## **Modification or Addition to Improvement Standards and Details**

AR - 4.7

DATE: 02/12/2007		7	NOT TO SCALE		CITY OF ELK GROVE - PUBLIC WORKS	APPROVED BY:		
REVISION	BY	APP	ROVED	DATE			CITY ENGINEER	
1	JP		RS	02/11/2009	SIDEWALK DRIVEWAY DETAIL			
							DRAWING NUMBER	
							AR - 4.7

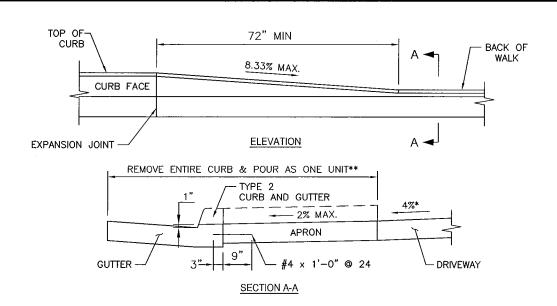
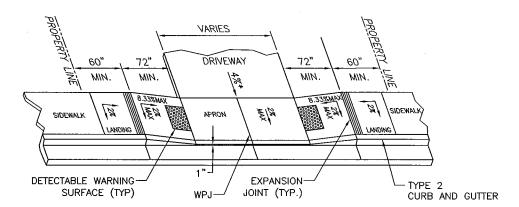
Effective Date of Change: 2/11/09		
Modification:		
1. Change 90" minimum on lower diagra above.	am to 72" minimum to be consisten	t with elevation
Effect of Modification:		
1. Correction to detail and consistency w	rith Standard Detail ST-20.	
	A.	
Request for Modification Initiated By:	Supervising Construction Inspecto	2.11.09 or Date
Modification Reviewed for Conformity and Consistency to Standards:	City Engineer	7(20\09 Date
Modification to Improvement Standards Approved:	Director of Public Works	7/20/09
